# PIC32MZ Graphics (DA) Family

## PIC32MZ Graphics (DA) Family Silicon Errata and Data Sheet Clarification

The PIC32MZ Graphics (DA) family of devices that you have received conform functionally to the current Device Data Sheet (DS60001361H), except for the anomalies described in this document.

FIGURE 1: Posc CRYSTAL CIRCUIT

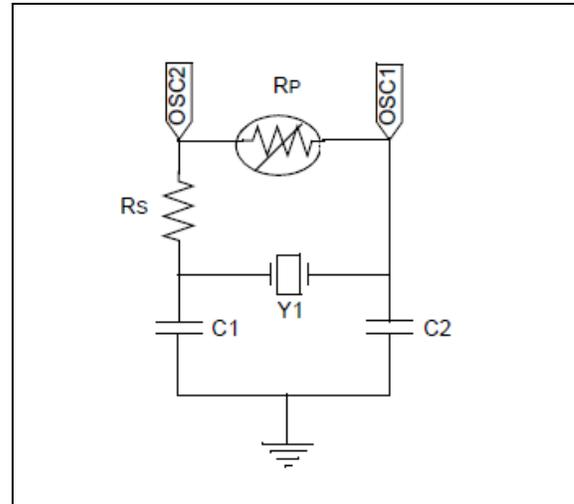
### 1. Module: Primary Oscillator

The POSC has been tested in a normal power-up sequence and supports specific crystal operation.

The Primary Oscillator (POsc) has been characterized to operate at 8 MHz and 12 MHz when the circuit shown in Figure 1 is implemented, and the operating conditions listed in Table 3 are met.

Alternatively, use an external clock or Internal FRC Oscillator. Note that communication interfaces (DDR2, USB, etc.,) with tighter clock accuracy requirements will not function with the FRC as clock source.

FIGURE 2: EXTERNAL RESET CIRCUIT

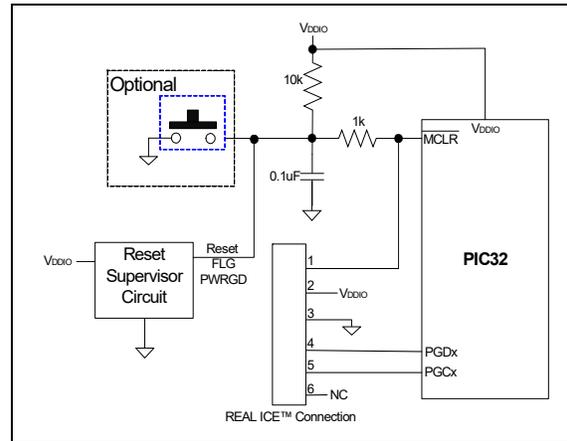
## 3. Module: Reset

A system Reset is not generated on a BOR event ( $V_{PORIO} < V_{DDIO} < V_{BORIO}$ ). This will stop system clocks with all the I/O pin functions frozen in the present state until either  $V_{DDIO}$  falls to  $V_{PORIO}$  or  $V_{DDIO} > V_{BORIO}$ .

Reset device using a  $\overline{MCLR}$  pin through an external reset supervisor/monitor is shown in Figure 2. Set the SMCLR (DEVCFG2<15>) configuration bit to '0', which makes the  $\overline{MCLR}$  to act as a POR Reset instead of a normal system reset.

When selecting an external supervisor other than the ones provided in Table 4 and Table 5, the following requirements must be taken into consideration:

- Minimum Reset trip voltage of the external supervisor should be  $V_{BORIO} (\text{Max}) + 0.5V$ .
- The external reset supervisor/LDO output going to  $\overline{MCLR}$  should have an open drain output to not interfere with the MPLAB programming/debug tools.

When this work around is implemented, the minimum  $V_{DDIO}$  operating voltage of the application needs to be above the reset supervisor maximum trip voltage + 0.2V, where 0.2V compensates for variation in the external reset supervisor voltage.
